Report on Review of Bay Delta Conservation Program Modeling

Since December 2012, MBK Engineers and Dan Steiner (collectively “Reviewers”) have assisted various parties in evaluating the operations modeling that was performed for the Bay Delta Conservation Plan (BDCP). To assist in understanding BDCP and the potential implications, stakeholders¹ requested that the Reviewers review the CalSim II modeling studies performed as part of the BDCP (hereafter “BDCP Studies” or “BDCP Model”).

Figure 23. South Delta Diversion at Banks

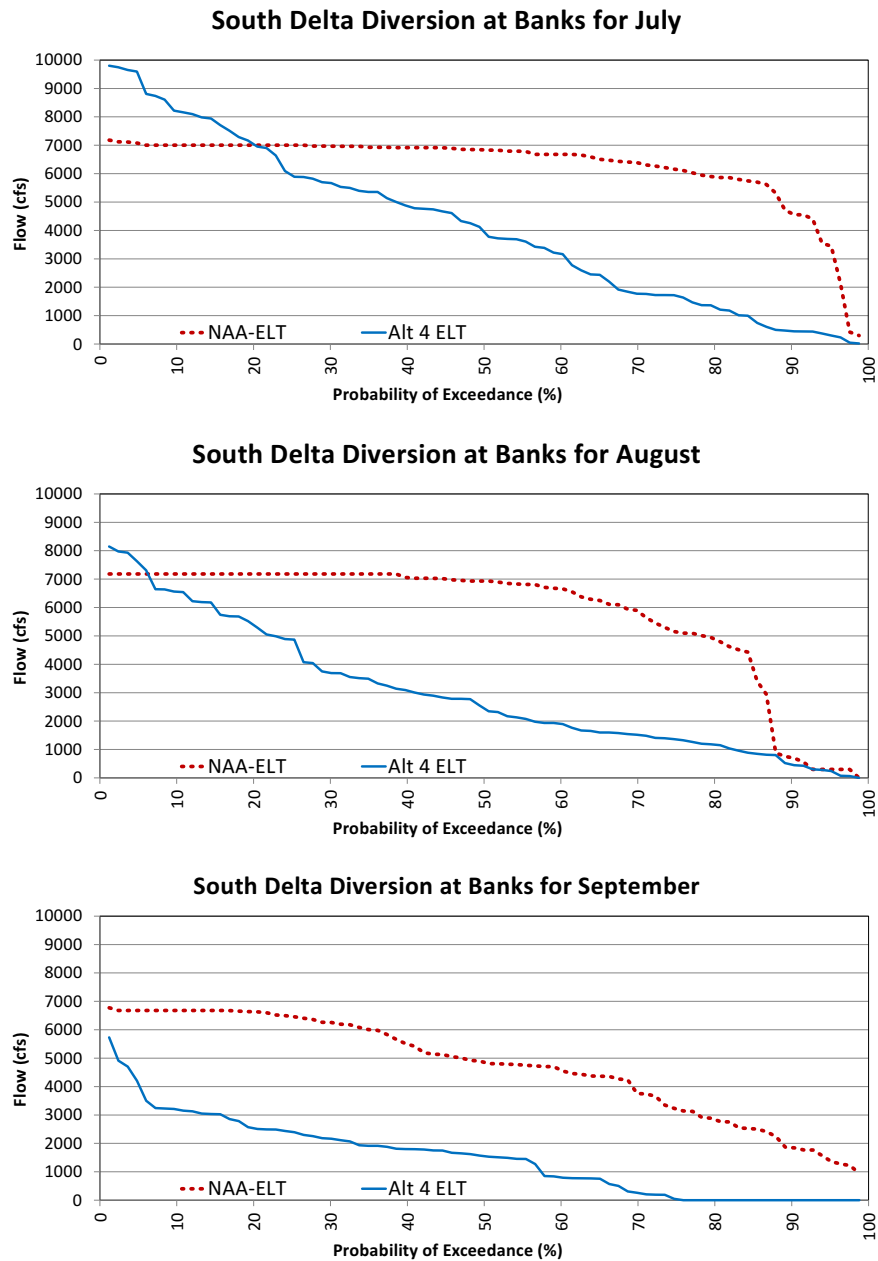
South Delta Diversion at Banks is not limited to existing permit capacity of 6,680 cfs and pumping may reach full capacity of 10,300 cfs in July, August, and September. Figure 23 contains exceedance probability charts of South Delta Diversion at Banks for July, August, and September. The chart for July shows SDD at Banks exceeding existing permit capacity 20% of years, in August this occurs in about 7% of years. There are South Delta diversions at Banks 25% of the time in September while diversions from the Sacramento River may range from 2,500 cfs to 7,500 cfs.

Figure 24. Delta Outflow Change (Alt 4-ELT minus NAA-ELT)

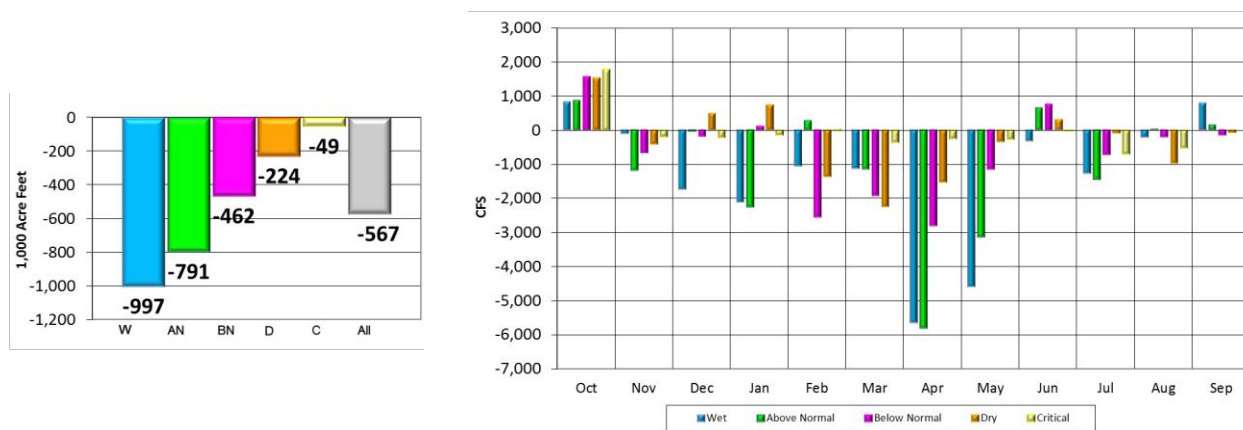
Figure 24 illustrates a comparison of Delta outflow between the NAA-ELT and Alt 4-ELT. Decreases in Delta outflow are the result of the CVP and SWP ability to increase Delta exports in Alt 4-ELT. The apparent increase in Delta outflow in October is partially due to additional export restrictions though Old and Middle River flow requirements. However, the increase in October Delta outflow is also due to an unrealistic operation of the Delta Cross Channel. The additional export restrictions cause the flow standards imposed at Rio Vista to be the controlling point in CVP and SWP operations; the water quality standards are all being met and do not require

flows above the amount needed to satisfy the Rio Vista standard. Meeting the Rio Vista flow standards without closing the Delta Cross Channel gate results in releasing more water from upstream reservoirs than would otherwise be necessary. This occurs because a certain amount of the water released to meet the Rio Vista flow standards would flow into the Central Delta at location of the Delta Cross Channel gate. This water would not make it to Rio Vista and therefore would not be counted towards meeting the Rio Vista flow standards. However, due to the BDCP model's assumed restrictions on exports at this time, this water could not be pumped from the South Delta facilities and thus ends up as "extra" Delta outflow. By closing the Delta Cross Channel gate, the operators would assure that all of the water released to meet the Rio Vista flow standards would be counted towards those standards. The BDCP model's assumptions that the Delta Cross Channel gate would not be closed are not practical or a sensible operation as the operators confirmed they would close the gate during these conditions to avoid the unnecessary loss of water supplies (as was done in October and November 2013). The assumption in the BDCP model to maintain the gate in the open position causes it to overstate the amount of Delta outflow.

Figure 58. Result Difference: Shasta Storage

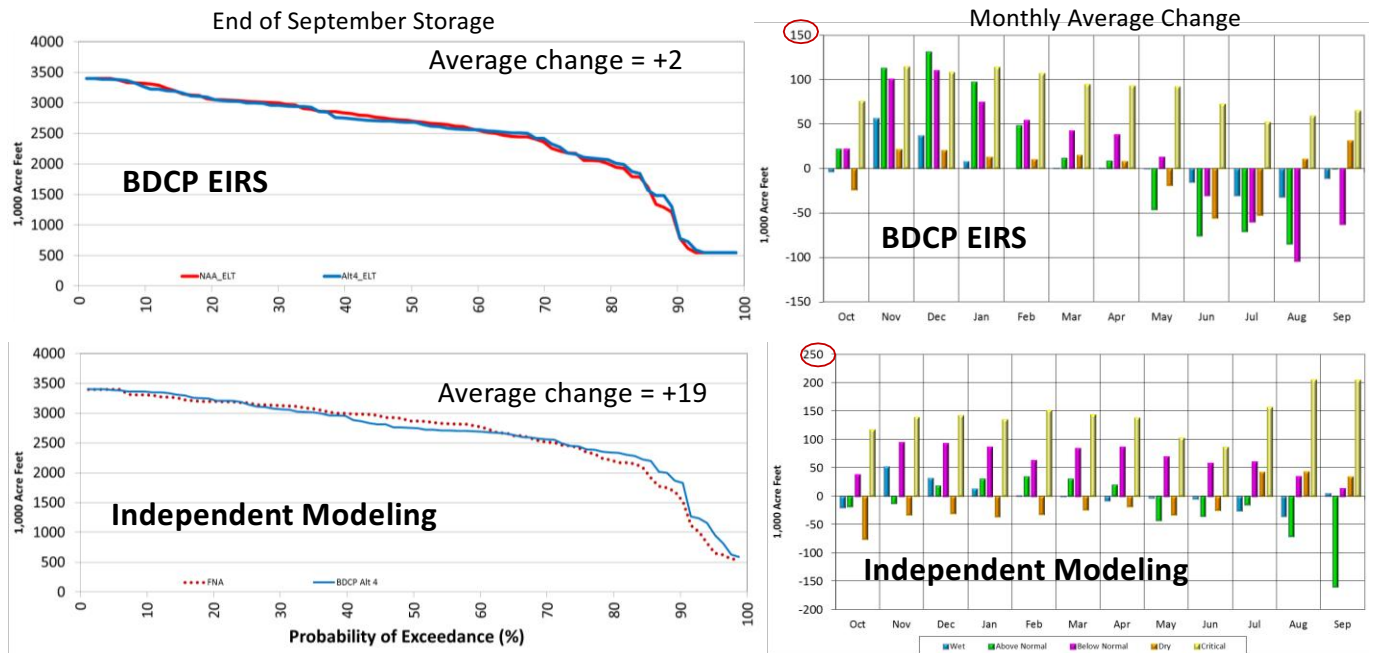
Reservoir operating rules for Alt4 in the BDCP EIRS modeling are changed relative to the NAA. In the BDCP EIRS modeling of Alt 4 rules are set to releases more water from upstream reservoirs to San Luis Reservoir from late winter through July, reduce releases in August, and then minimize releases to drive San Luis Reservoir to dead pool from September through December. This operation is inconsistent with actual operations and causes reductions in upstream storage from May through August. Figure 58 and Figure 59 contain exceedance probability plots of carryover storage and average monthly changes in storage by water year type for Shasta and Folsom for the BDCP and independent modeling. Although carryover storage for Alt 4 and the NAA is similar in the BDCP EIRS modeling, there is drawdown from June through August that may cause impacts to cold water pool management. In the independent modeling upstream reservoirs are drawn down more in years when storage is available while dryer year storage is maintained at higher levels, this is illustrated in the carryover plots for Shasta and Folsom in Figure 58 and Figure 59.

Figure 60. NDD, and Sacramento River Flow

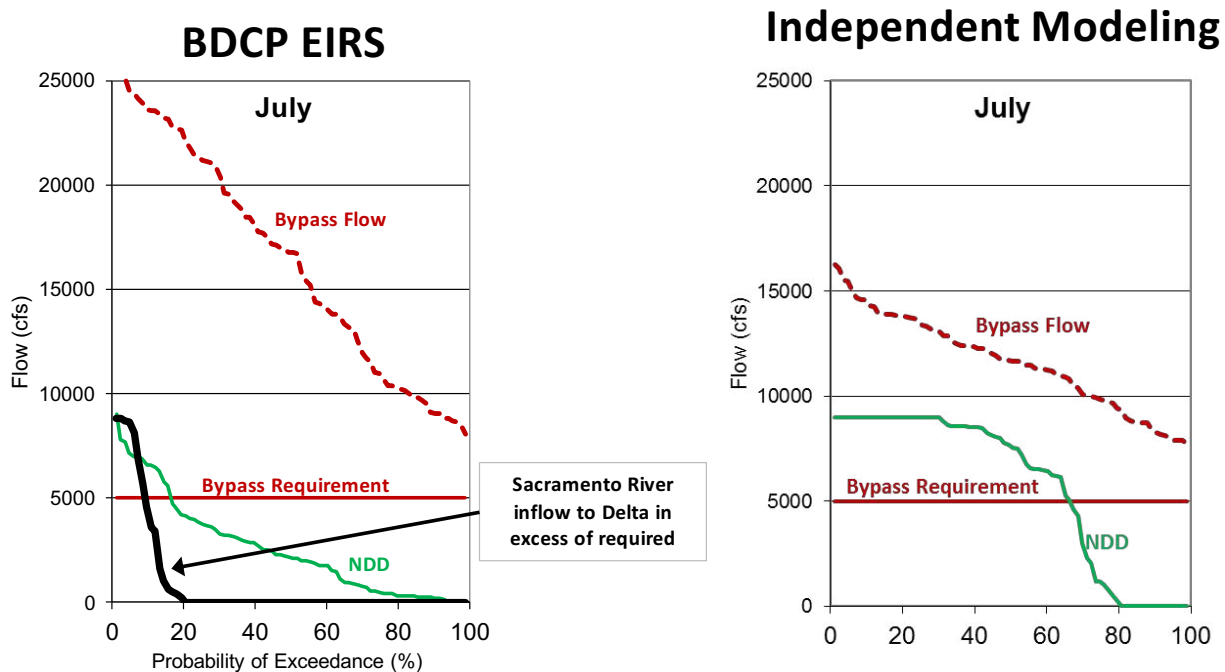
Independent modeling shows greater NDD during July and other months because the BDCP EIRS modeling includes artificially high Sacramento River bypass flow requirements. Figure 60 contains exceedance probability plots of Sacramento River required bypass, Sacramento River bypass flow, NDD, and excess Sacramento River flow to the Delta. As can be seen in Figure 60, bypass flow is always above the bypass requirement. The BDCP version of CalSim sets a requirement for Sacramento River inflow to the Delta that the independent modeling does not need in order to satisfy Delta requirements, therefore the NDD is higher in the independent modeling.
